## FINAL ORDER

The Special Standards Request Form you submitted for owner: Design LLC, Start Card numbers: 1057867 through 1057869, is hereby approved for the following: you may decommission these water supply wells (WASC 3249, WASC 3255, and WASC 3256), as described on your Special Standards Request Form dated August 4, 2022, and Proposed Well Abandonment Schematics. All other well abandonment standards apply as required under Oregon Administrative Rules 690-220. A copy of your Special Standards Request Form is enclosed.

# Special Standards Request Form

**FIGURE 1**  
**Proposed Well**  
**Abandonment Schematic**  
**Well 4 (WASC 3249)**

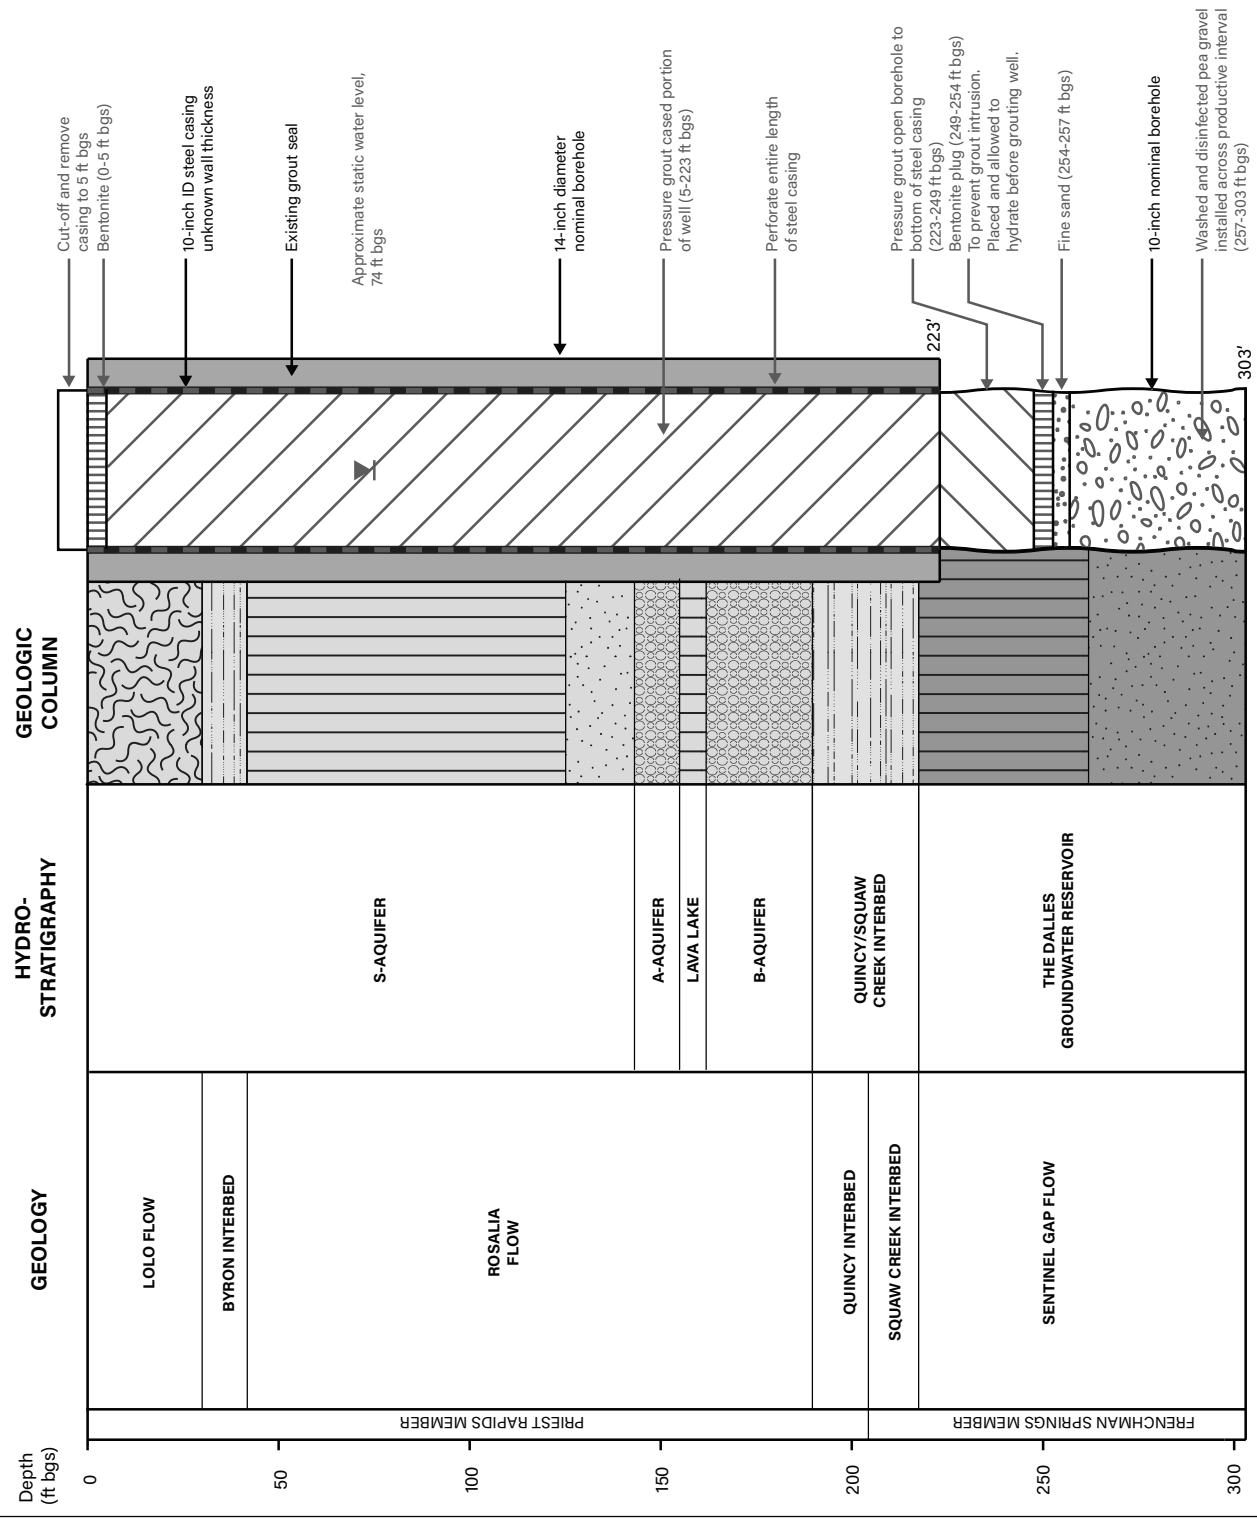
Thank you for the discussion this morning regarding the proposed abandonment procedure for the former Northwest Aluminum Company production wells in The Dalles (WASC 3256, WASC 3255, and WASC 3249). I wanted to confirm that per our discussion, the abandonment procedure outlined on the attached figure is consistent with the Departments rules for abandonment of wells. Also, I understand that the Department does not have any concerns if additional casing is removed and bentonite used at ground surface (increasing from 0-5 ft in the attached figure to 0-10 ft) to facilitate grading of the ground surface during subsequent redevelopment of the property.

Your proposal to abandon these well is acceptable by the Department. It is also acceptable to cut off the upper 10 feet of the casing during abandonment to allow for grading of the lot.

**FIGURE 2**  
**Proposed Well**  
**Abandonment Schematic**  
**Well 1 (WASC 3256)**

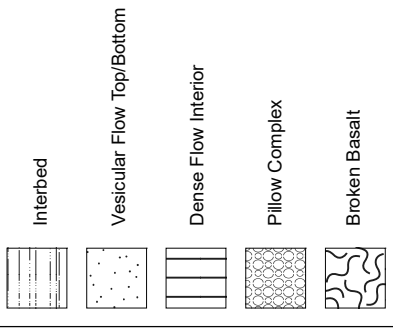
The new owners of the former Northwest Aluminum Company production wells in The Dalles (WASC 3256, WASC 3255, and WASC 3249) are planning to abandon the wells. We have developed a plan for the abandonment of the wells, which was developed to meet the standards for abandonment per the Department's Div 220 rules; however, our plan includes some extra steps in the procedure that were developed in consultation with EPA & DEQ to address concerns regarding the shallow groundwater contamination present on the property where the wells are located. I've attached a schematic showing the abandonment approach for Well 1 for discussion; however, the abandonment approach is the same for all three wells.
